RE: Cornerstone Mixed-Use Project – Mitigated Negative Declaration, Cultural Resources

INITIAL STUDY, MITIGATED NEGATIVE DECLARATION, "AGOURA VILLAGE DEVELOPMENT PROJECT," REQUEST FOR THE PLANNING COMMISSION TO APPROVE AN AGOURA VILLAGE DEVELOPMENT PERMIT AND TENTATIVE PARCEL MAP TO CONSTRUCT A MIXED-USE COMMERCIAL AND MULTI-FAMILY RESIDENTIAL PROJECT CORNERSTONE CONSISTING OF 35 RESIDENTIAL APARTMENT UNITS, RETAIL, RESTAURANT, AND OFFICE SPACE, SOUTH EAST CORNER OF AGOURA ROAD/CORNELL ROAD, AGOURA HILLS, FFER 201600212

Subject: Planning Commission January 5 approval of Agoura Village Development Permit and Tentative Parcel Map, hereinafter "Cornerstone"

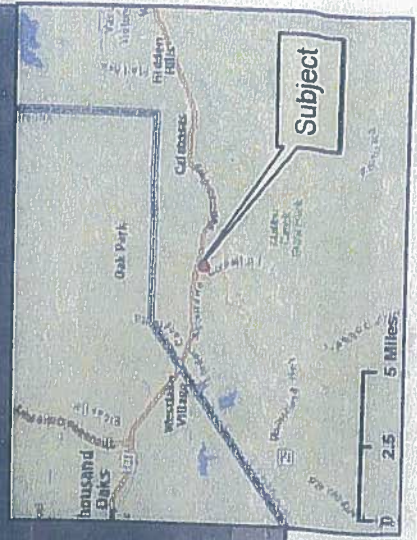
The Rim of the Valley Trail Corridor Master Plan includes a spur from the Rim of the Valley Trail leading from Cheseboro Canyon across the 101 freeway and along the south side of Agoura Road to the project site by the Cornell Road intersection. The MND is deficient for not addressing the existence of this planned spur trail and potential adverse impacts to the unofficial City trail along Cheseboro Creek and Agoura Road.

In addition the National Park Service has a planned trail (Agoura Equestrian Center Connector) that comes from Cheseboro Canyon and then along the north side of Agoura Road (Zuma Ridge Trail), up a short stretch of Cornell Road and then up the paper street through the proposed development (Paramount Ranch Connector Trail). The MND is deficient for not addressing the existence of these planned trails. All have been part of the NPS Trails Plan since at least 2004. Any approved project should include an unpaved trail through the property to achieve the connectivity and public purposes of these planned trails.
